AMENDMENT OF SOLICITATION/MODIFICATION OF CONTRACT				1. CONTRACT ID CODE	PAGE OF PAGES
				J	1 6
2. AMENDMENT/MODIFICATION NO. 0001	3. EFFECTIVE DATE 25-Jan-2006	4. REQUISITION/PURCHASE REQ. NO.		5. PROJECT NO.(If applicable)

14. DESCRIPTION OF AMENDMENT/MODIFICATION (Organized by UCF section headings, including solicitation/contract subject matter where feasible.) The above numbered solicitation for Lake Pontchartrain, Louisiana and Vicinity, New Orleans Area Plan Emergency Restoration, Interim Closure Structure Orleans Avenue Canal, Orleans Parish, Louisiana is hereby amended as follows: The scheduled proposal due date of 26 January 2006, 10:00 A.M. local time remains unchanged.					
Except as provided herein, all terms and conditions of the document referenced in Item 9A or 10A, as heretofore changed, remains unchanged and in full force and effect.					
15A. NAME AND TITLE OF SIGNER (Type or print)			16A. NAME AND TITLE OF CONTRACTING OFFICER (Type or print)		
			TEL: _____ EMAIL: _____		
15B. CONTRACTOR/OFFEROR	15C. DATE SIGNED	16B. UNITED STATES OF AMERICA		16C. DATE SIGNED	
_____ (Signature of person authorized to sign)		BY _____ (Signature of Contracting Officer)		25-Jan-2

FILE NUMBER
DWG. 6 OF 26

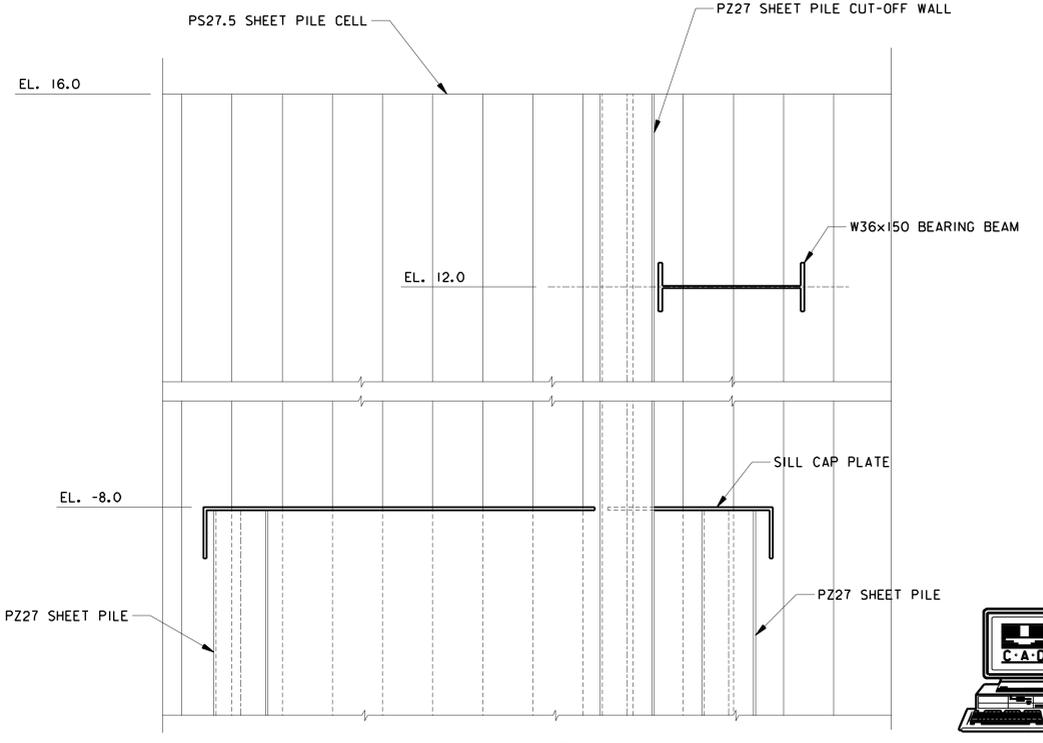
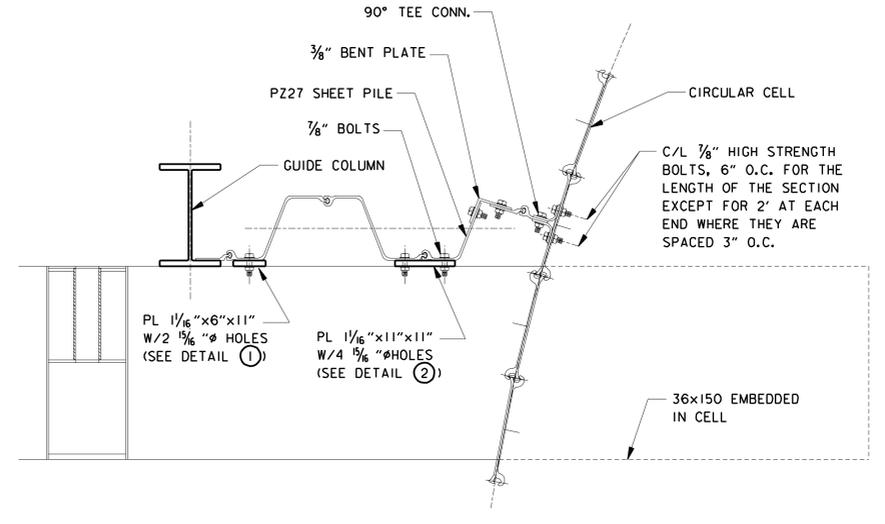
Delete drawings 2, 5A, 6, 13, 16 of 26 in their entirety and replace with revised drawings 2, 5A, 6, 13, 16 of 26.

NOTE:
1. TIE-IN SHOWN FOR EAST END OF CLOSURE STRUCTURE. TIE-IN FOR WEST END OF CLOSURE STRUCTURE WILL BE OPPOSITE HAND.
2. TIP ELEVATION FOR SHEET PILE AT TIE-IN SHOULD BE EL. -15.0.
